## Partial Width, Density Optimized HPM Form Factor (M-DNO) Base Specification

M-DNO\_R1\_v1p0 Errata Document

January 19, 2023

## Errata #1

ECN 1 Figure 35 Update

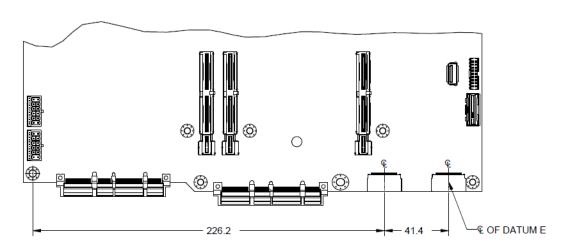
Impacted Specification Section(s): 10.13.2 – Direct Dock E1.S
Impacted Specification Figure(s): Figure 35: Direct Dock E1.S in Custom Zone
Impacted Reference CAD: m-dno-type4-221014-E1s.stp
m-dno-type4-221011-all-conns.stp

The provided recommended dimensioning in **Figure 35** is incorrect and results in a collision between the required OCP NIC R3 location and one of the E1 modules.

The updated recommendation is provided below. Note that dimensioning has been changed to reference the centerline of Datum E in the SFF-TA-1002 connector specification. Additionally, the new location allows for either 1C or 2C connector variants to be placed.
